PLAN COMMISSION AGENDA

STAFF REPORT

Agenda Item: **6.a.**

Fletcher Arms Parking Lot Improvements

SHEET CONTENTS
 PROPOSED EROSION CONTROL PLAN

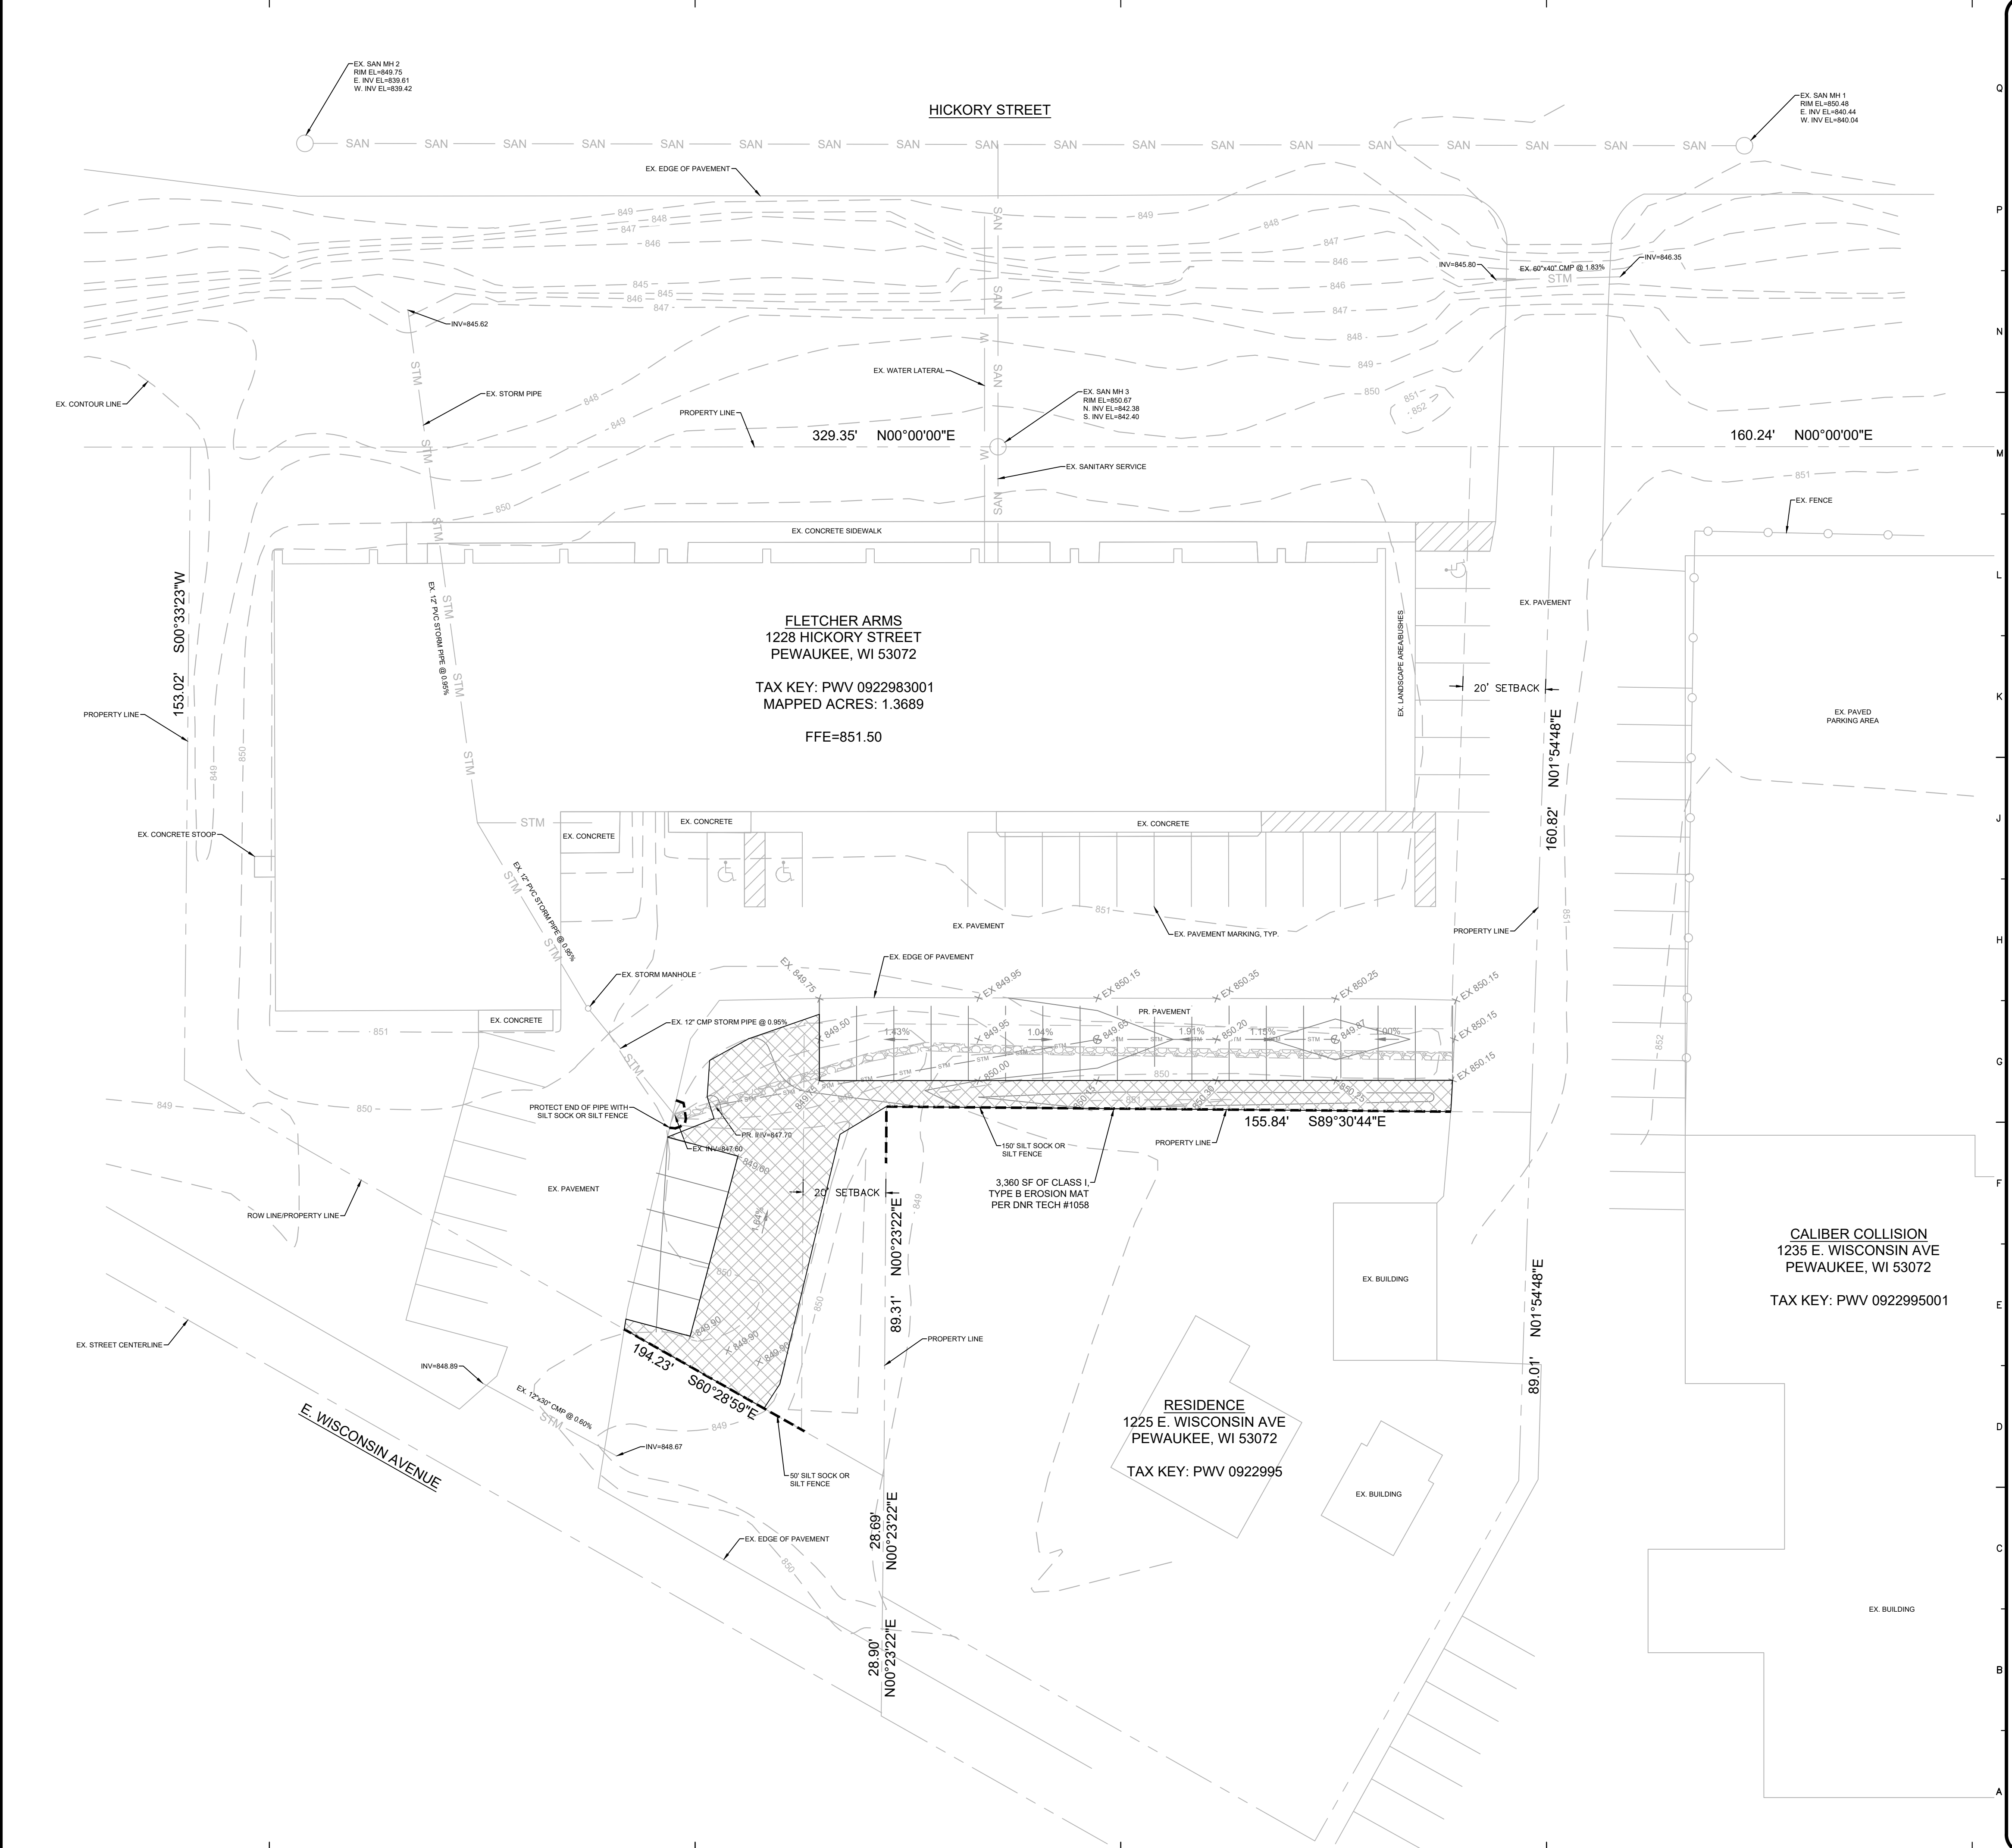
An erosion control plan has been provided in the plan set. Erosion control features will include a tracking pad at the entrance off of E. Wisconsin Avenue, silt sock at the storm pipe entrance and erosion matting over disturbed turf areas.

SHEET CONTENTS
PROPOSED SITE PLAN

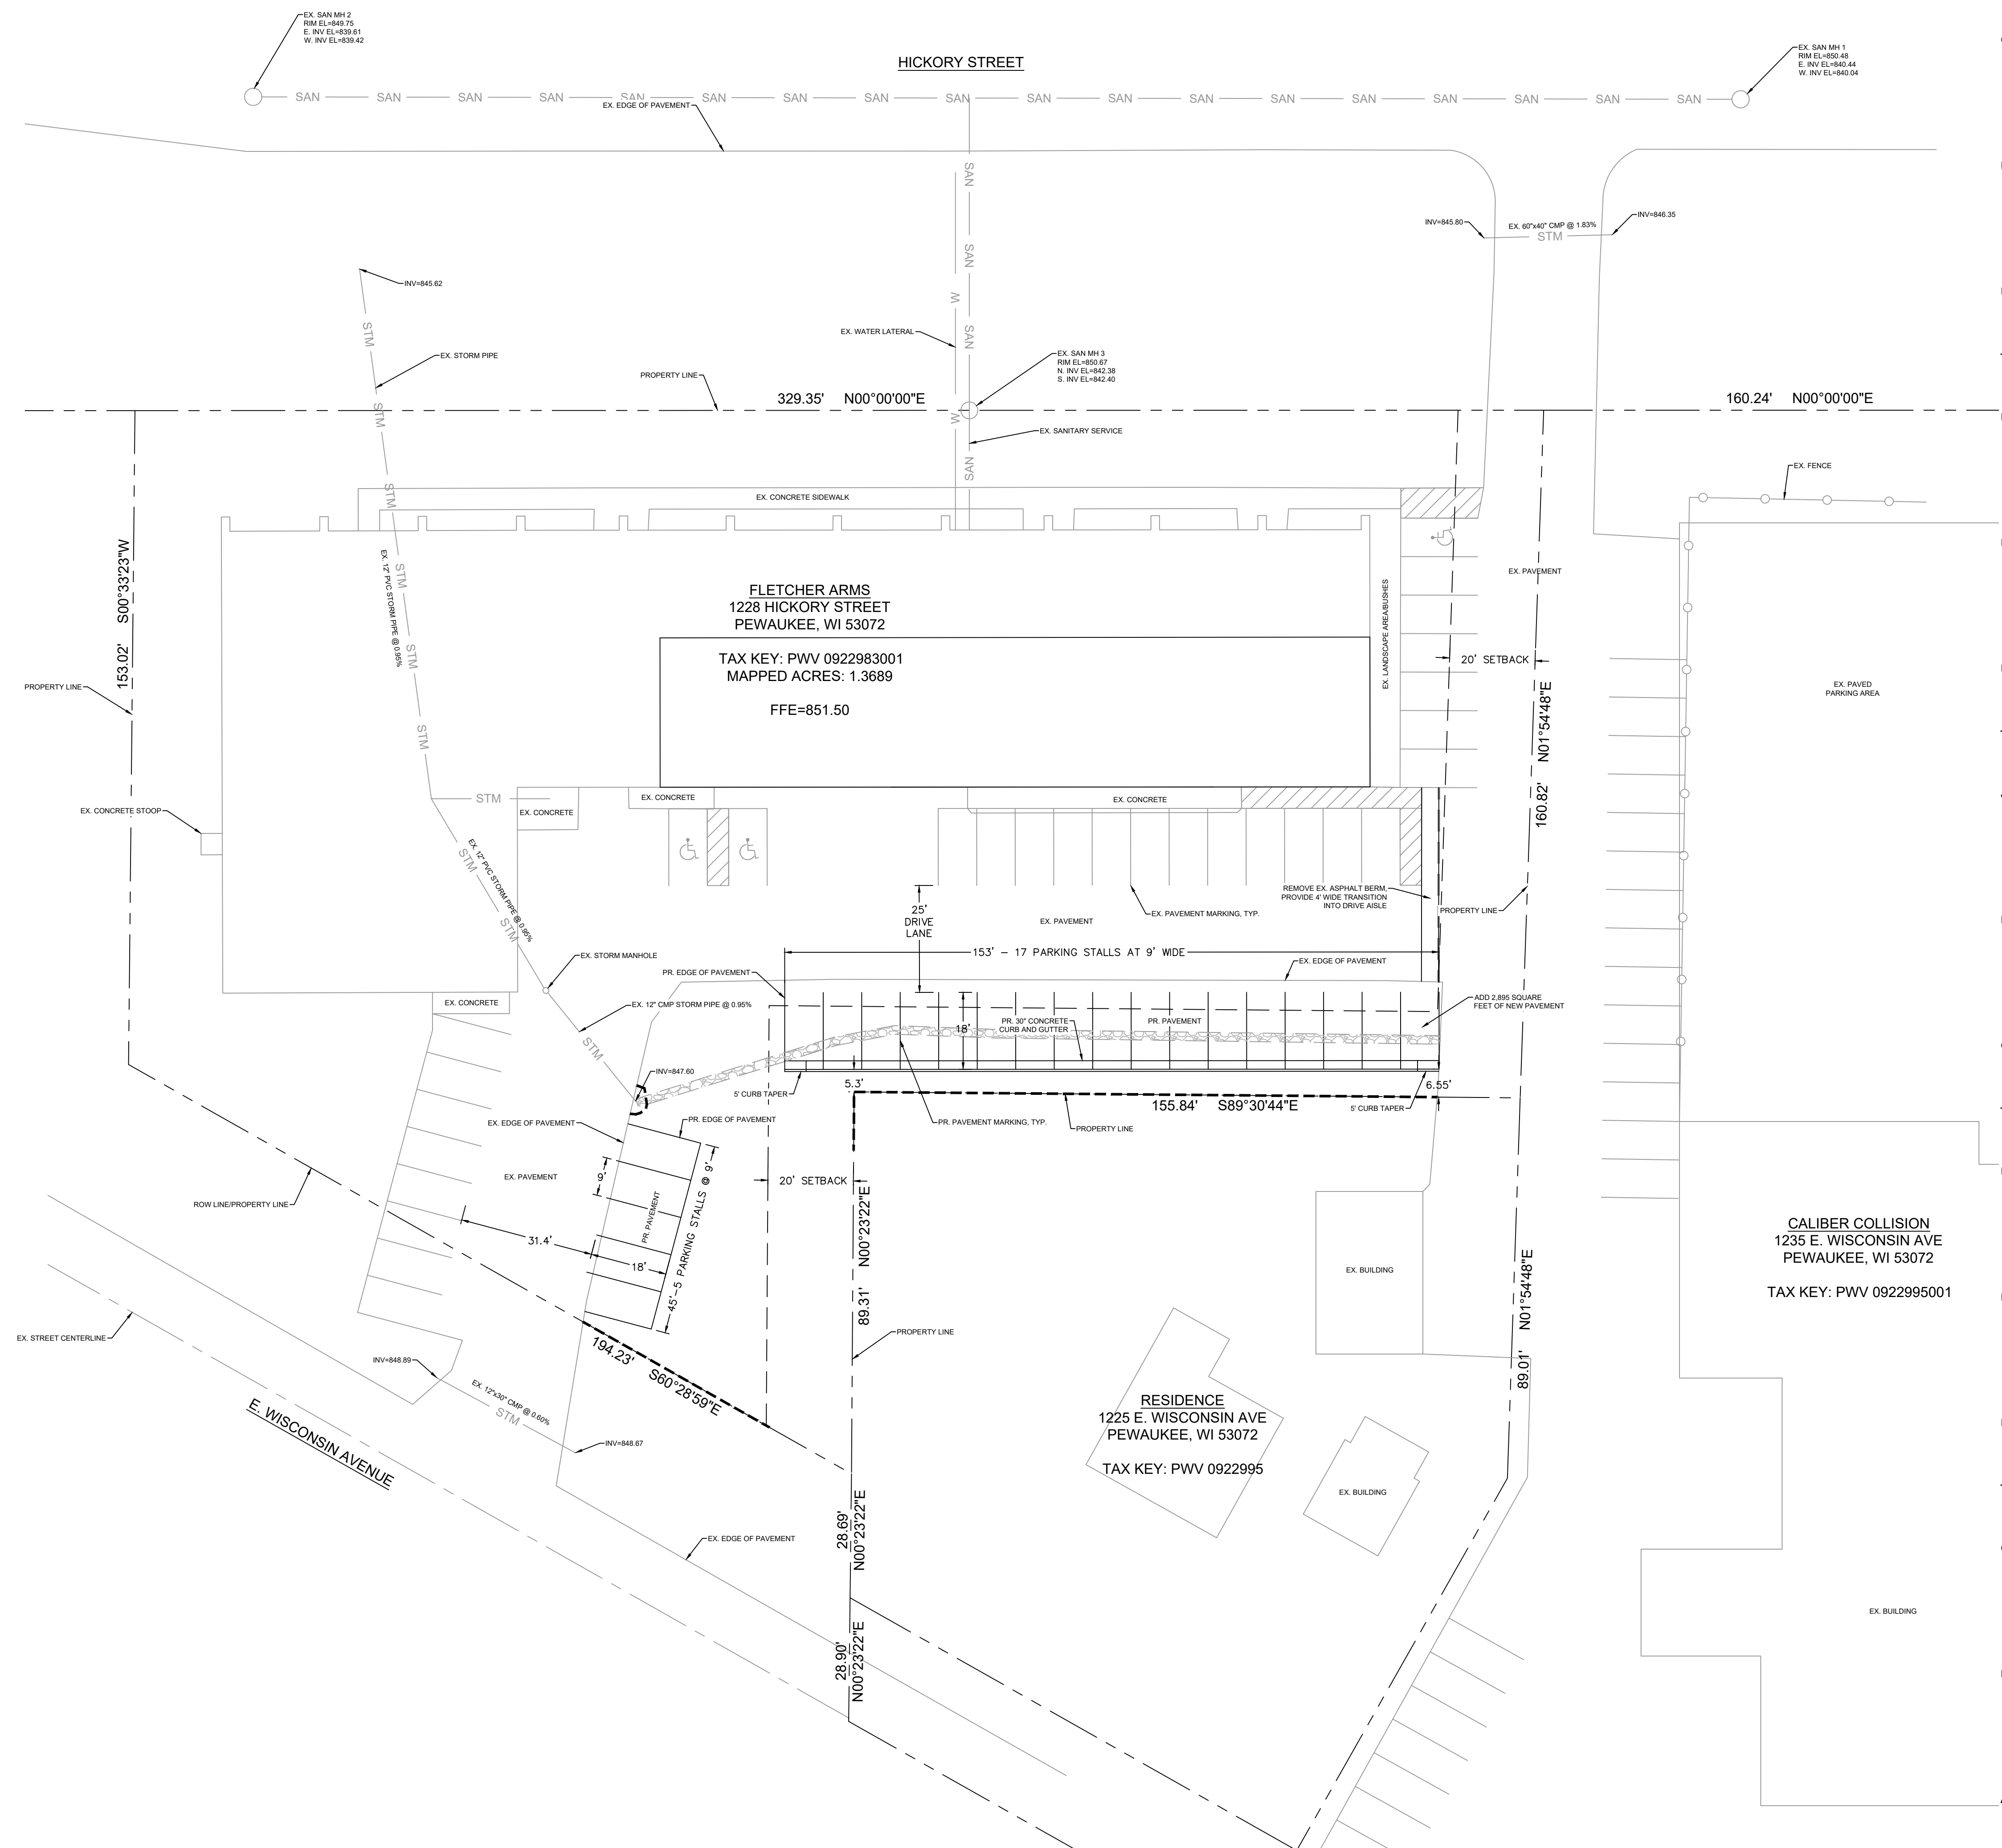
The applicant proposes to add 22 paved parking stalls at this site – five located along the east side of the main entry drive that enters from E. Wisconsin Avenue and 17 in a new bay to be added directly across from the existing stalls along the south wall of the building. In both cases, the existing land use directly abutting the new parking stall bays is a single family residence (that is zoned B-1 Community Business).

Sec. 40.325 of the Code provides that “No driveway or parking area in the B-5 district shall be located closer than 20 feet from a side or rear lot line unless specifically waived by the planning commission”. The applicant proposes to place the 17-stall bay at a 6.3-foot to 7.55-foot offset to the south lot line.

- 1) Planning Commission express consideration and possible approval as to the parking offset waiver (i.e., 6.3-foot to 7.55-foot offset to the south lot line where 20 feet would otherwise be required).
- 2) Applicant to prepare a suitable landscaping/screening plan for installation along the south side of the new 17-stall bay and along the east side of the new 5-stall bay of parking stalls

that will minimize the aesthetic conflict between this business use/parking and the existing residential use adjoining. This plan shall be approved by Village Staff prior to the start of construction on the new parking areas and it shall be fully installed/implemented within 9 months of the date of this approval.
